Effluent Limitations Guidelines and Standards for the Steam Electric Power Generating Point Source Category: EPA's Response to Public Comments

Part 5 of 10

7. Industry Operations

Figure 4: Nitrate/Nitrite-N Levels in Treated Chemical Precipitation Effluent for the Seven Plants EPA Sampled

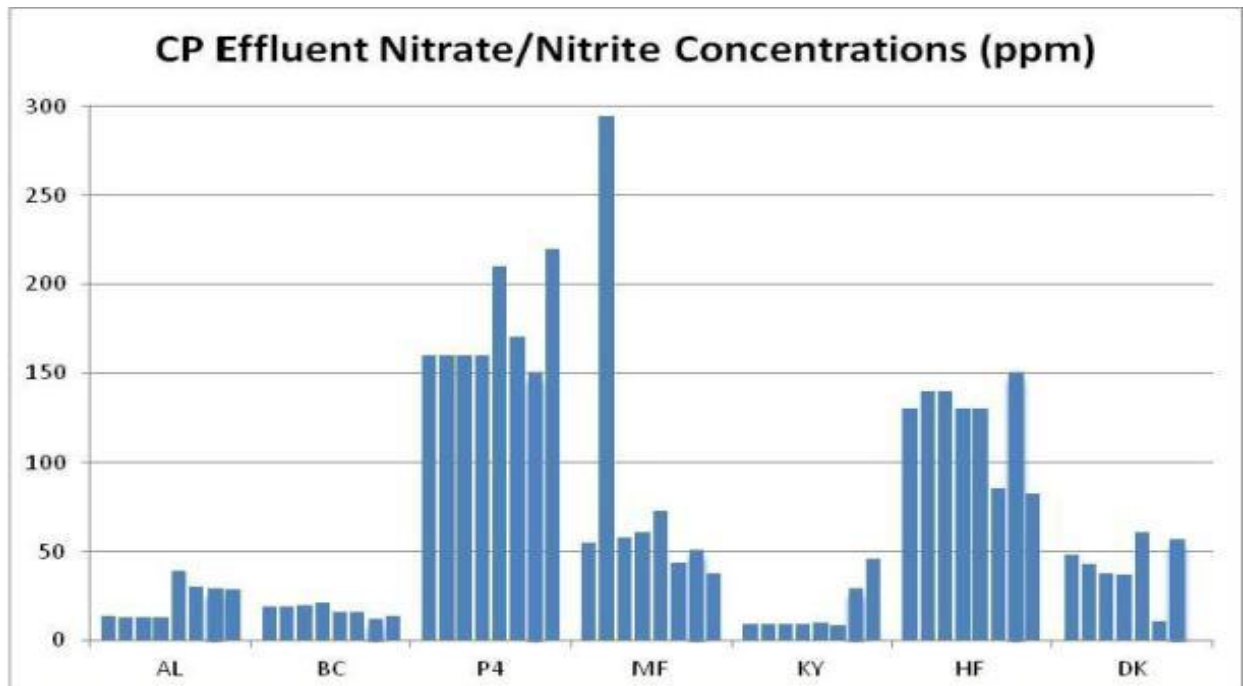
Also, Belews Creek and Allen have lower nitrate/nitrite-N levels than Dickerson, Miami Fort, Hatfield’s Ferry, and Pleasant Prairie. Hatfield’s Ferry, Miami Fort and Pleasant Prairie have nitrate/nitrite-N influent levels that are greater than the 100 mg/L design specification for the GE ABMet biological treatment system. EPA’s own sampling data show that nitrate/nitrate-N concentrations vary greatly between plants. The chemical precipitation effluent for these plants range from <10 to 300 mg/L. (EPA Sampling Episode Reports). Figure 4 below shows the nitrate/nitrite-N concentrations for both the 4-day and the monthly sampling events.

Belews Creek and Allen biological treatment systems target selenium removal but not nitrogen removal. EPA has not evaluated any biological treatment systems that optimize both selenium and nitrate/nitrite removal, and in particular, treatment systems that receive higher selenium *and* higher nitrate/nitrite levels.

Figure 3-3
Influent Nitrate/Nitrite Data for EPA Sites

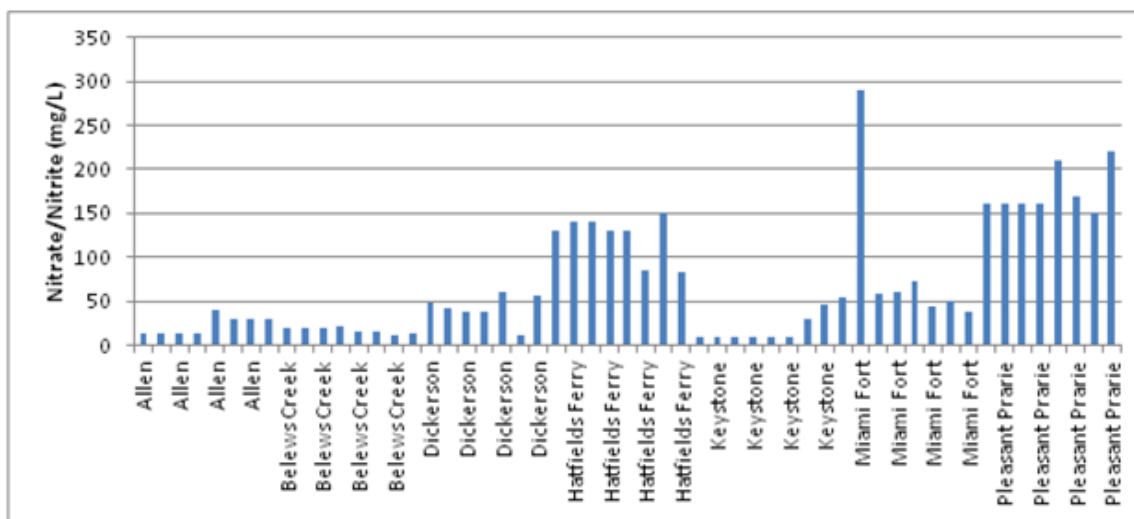
Belews Creek and Allen have very similar influents, and thus do not capture the true variability of FGD wastewater within the industry. Influent nitrate/nitrite concentrations varied widely among facilities where EPA conducted sampling (Figure 3-3). Influent nitrate/nitrite levels at the Belews Creek and Allen facilities are low in comparison to the other sites tested. Figure 3-3 shows nitrate/nitrite levels of up to 290 mg/L based on EPA sampling or CWA 308 plant monitoring [EPA, 2012a–g].

Figure 3-2
Comparison of Particulate and Dissolved Selenium in FGD Wastewater Influent

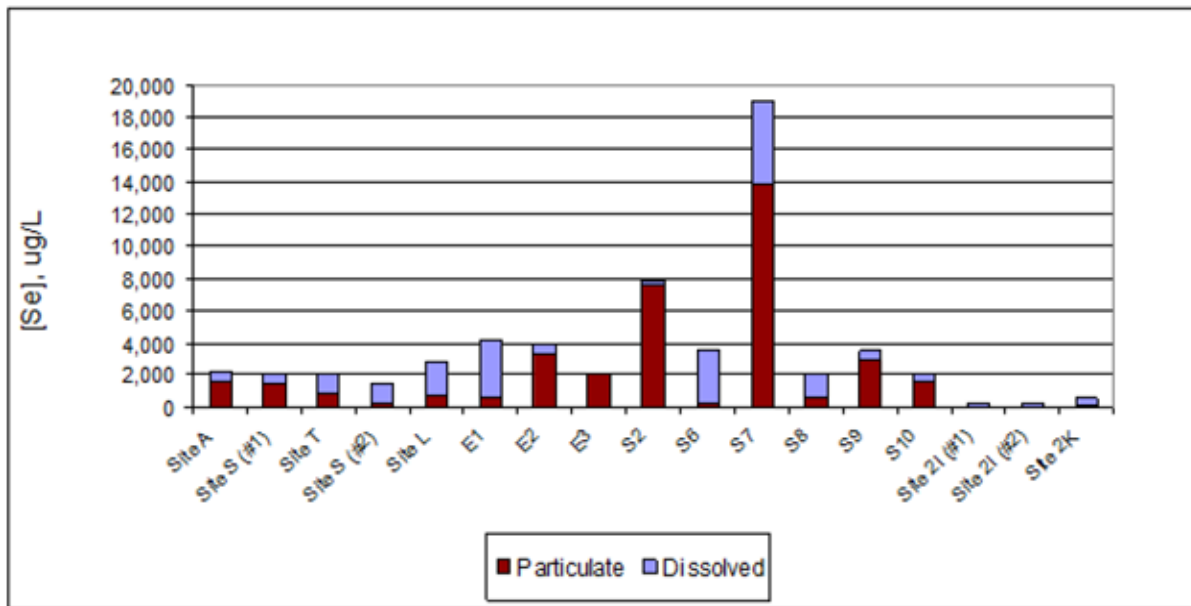
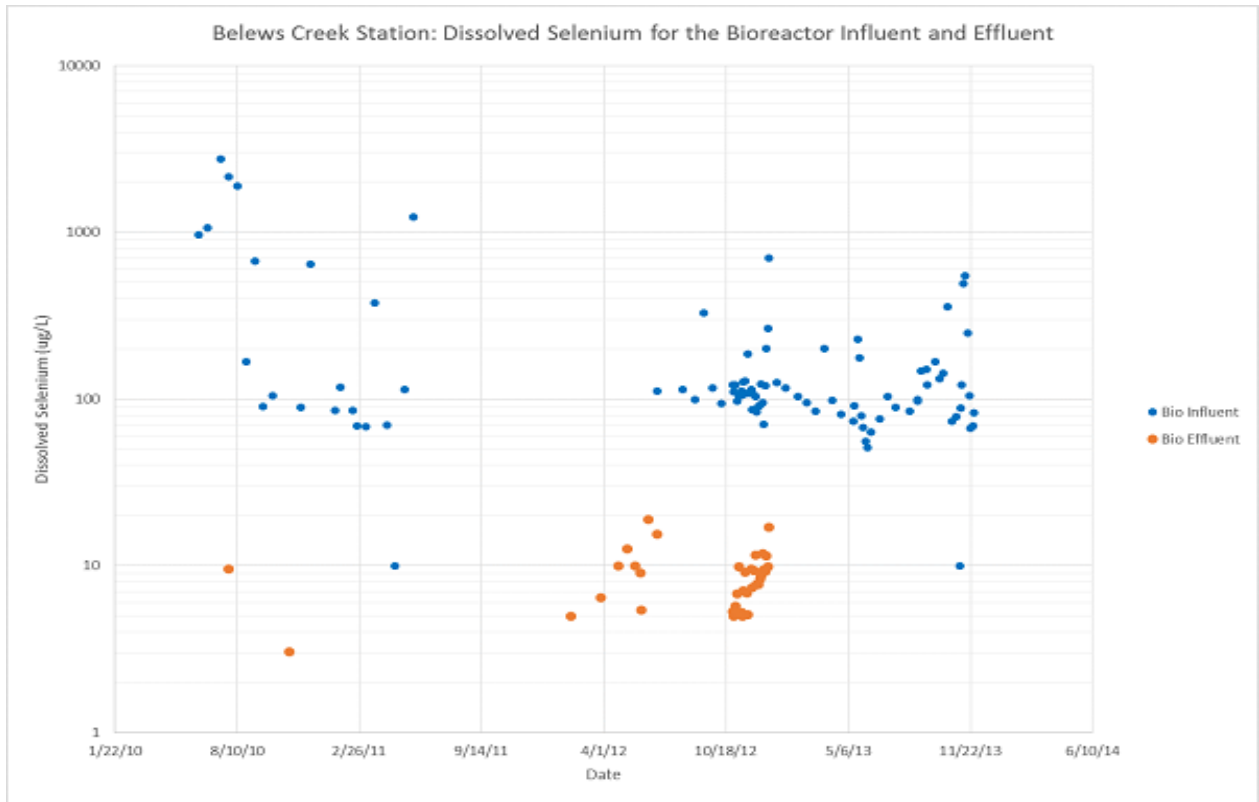
Coagulation and physical separation are used as part of the chemical precipitation process to remove particulate selenium. Anaerobic biological treatment is used as the technical basis to remove dissolved selenium. Figure 3-2 shows that the fraction or split of particulate and dissolved selenium (as compared with total selenium) within a facility varies widely among plants. The fraction of dissolved selenium is critical, as this is the more challenging fraction to treat. The fraction of dissolved selenium also varies widely between plants, and at a given facility over time. Based on the long-term self-monitoring data that EPA received from Belews Creek, the average total selenium concentration in the FGD purge stream is 5,676 µg/L but the influent dissolved selenium concentration is 542 µg/L. Various sites shown in Figure 3-2 [EPRI, 2010a] have influent dissolved selenium concentrations that are much greater than the average Belews Creek dissolved selenium levels.

EPA partially agrees with the commenter that dissolved selenium is “the more challenging fraction to treat.” EPA agrees that the dissolved selenium is difficult to treat in a chemical precipitation system; however, EPA disagrees with the commenter that dissolved selenium is difficult to treat in the biological treatment system. EPA’s record demonstrates that the biological treatment system component of the BAT basis is capable of treating both total and dissolved fractions of selenium. See the data in the plots below showing the removal of dissolved selenium across the bioreactor. These data were submitted in March 2014 by Duke Energy for Allen and Belews Creek Stations, and by AEP for the Mountaineer Plant (dissolved selenium for the bioreactor influent and effluent is shown on the plots below). See also Earthjustice’s comment on the achievability of dissolved selenium treatment in DCN EPA-HQ-OW-2009-0819-4702-A7, Excerpt Number 3 in Comment Code 10.a.

Figure 5: Arsenic Concentrations at Selected Plants – Influent (Dissolved) and Chemical Precipitation Effluent (Total)

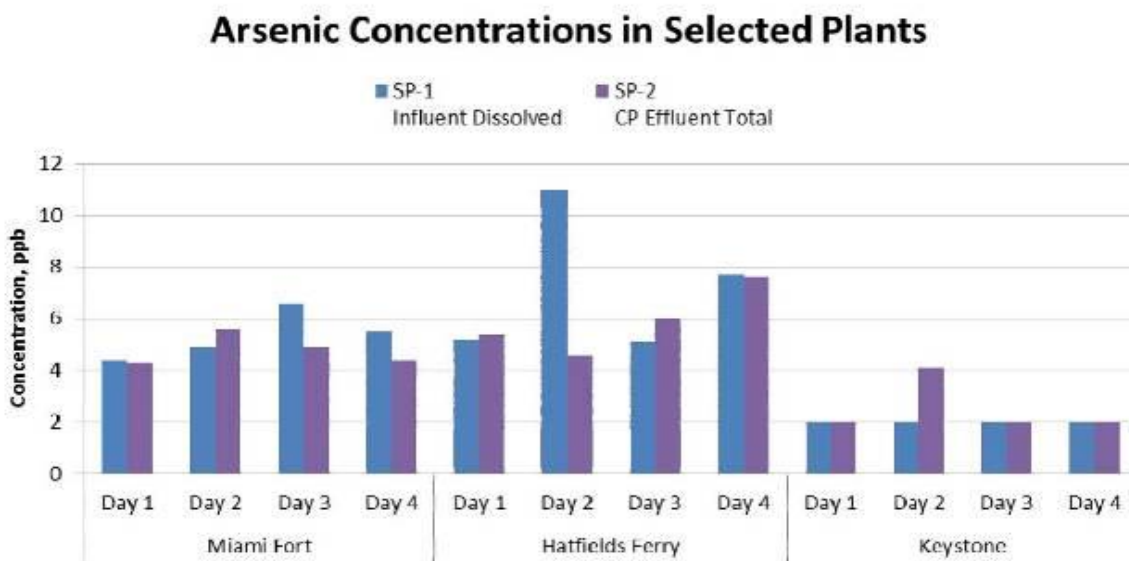
Additionally, as shown in Figure 5, the influent dissolved arsenic concentrations for the proposed BAT plants (Miami Fort, Hatfield's Ferry, and Keystone) range from < 4 to 11 µg/L, which in most instances are below the proposed limits of 6 µg/L monthly average and 8 µg/L daily maximum. The dissolved arsenic levels in these proposed BAT plants are not high enough to properly evaluate the effectiveness of these treatment systems. Based on EPA's criteria for identifying pollutants of concern (POCs), arsenic in FGD wastewater does not qualify as a POC. 2013 TDD, p. 6-25.

Figure 4-3
Estimates of Constituent Removal Using Biological Treatment

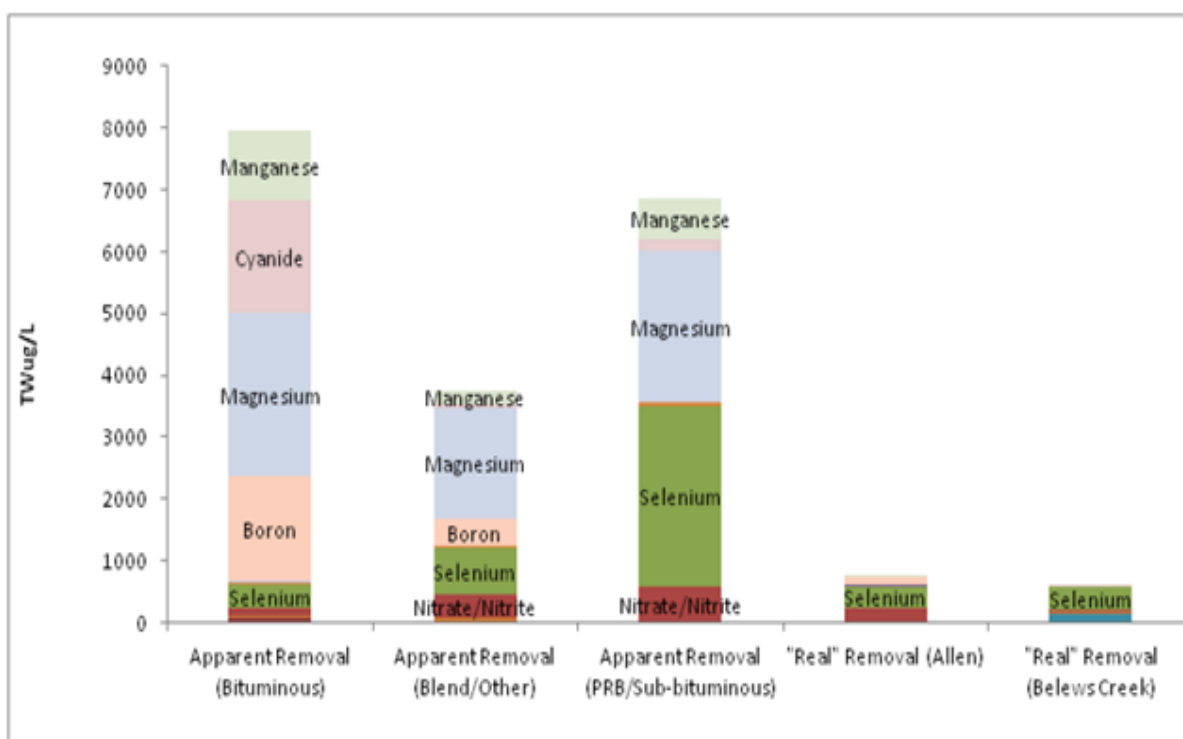
Figure 4-3 shows calculated removal of constituents when the influent to the biological system represents the average of data from four plants using CP treatment (Hatfield's Ferry, Keystone,

Miami Fort, Pleasant Prairie) and the effluent represents the average of data from two different plants using biological treatment (Allen and Belews Creek). EPA did not include Pleasant Prairie data in the present calculations. Because Pleasant Prairie's FGD wastewater treatment system meets the definition of BAT and its use had a minimal impact on CP effluent (Figure 4-1), EPRI recommends that the Pleasant Prairie data be included.

Because the four plants providing influent data have higher concentrations of manganese, cyanide, boron, and magnesium than the two plants (Allen and Belews Creek) providing effluent data, it falsely appears that removal of these constituents is occurring. It is important to evaluate the removal of these constituents at each individual plant using its own influent and effluent streams (as is done in Table 4-5). Figure 4-3 shows much lower biological removal at Allen and Belews Creek when this procedure is followed.

Figure 4-4
Comparison of Biological Influent for Plants Used in Treatment Evaluation
Source: ERG, 2011a-f

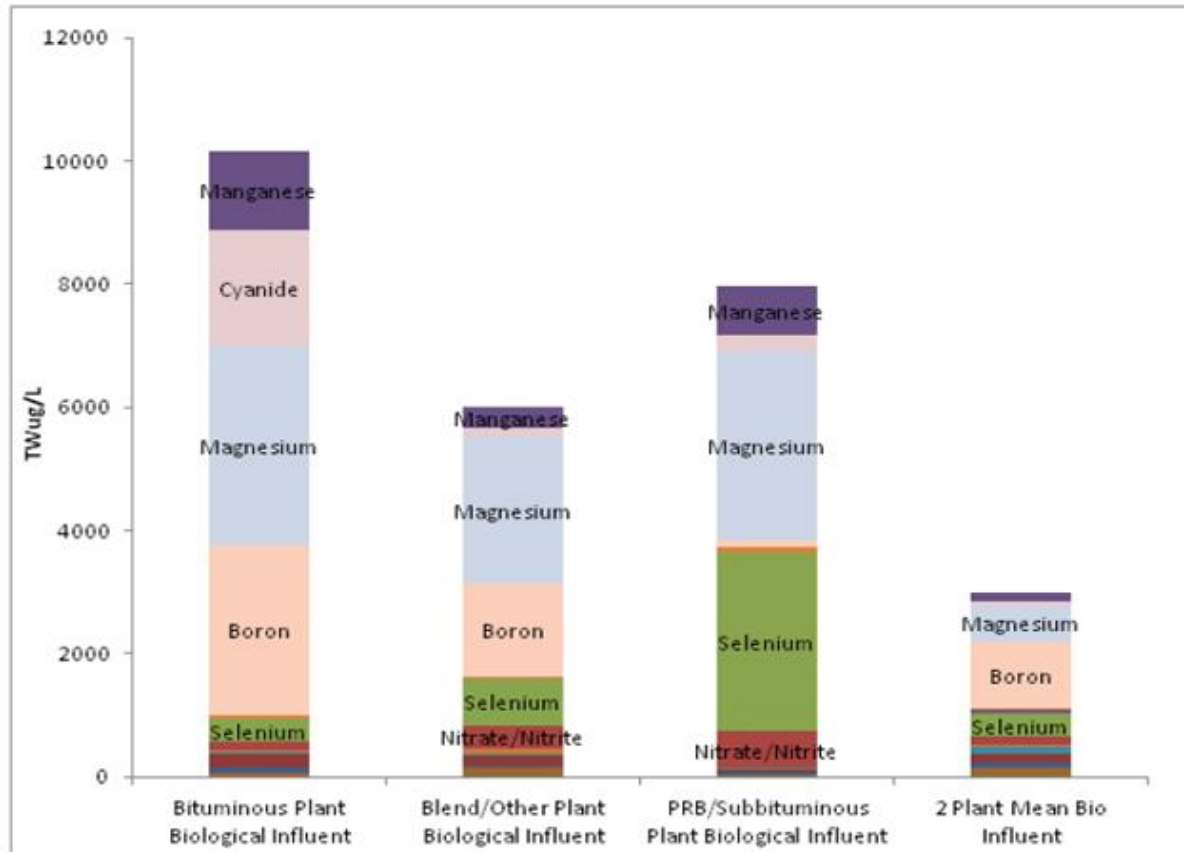
The average concentrations of manganese, cyanide, magnesium, and boron in influent and effluent streams of biological treatment are shown in Table 4-5. Little to no removal of these constituents occurs at Allen and Belews Creek. Figure 4-4 shows how CP Effluent (which is the same as Biological Influent) differs between the four plants used for CP evaluation by coal type and the two plants used for Biological Effluent. As illustrated in Figure 4-4, the four plants used for CP evaluation have much higher average concentrations of manganese, cyanide, magnesium, and boron than the two plants used for Biological Effluent. This leads to the false appearance of constituent removal, as described above.
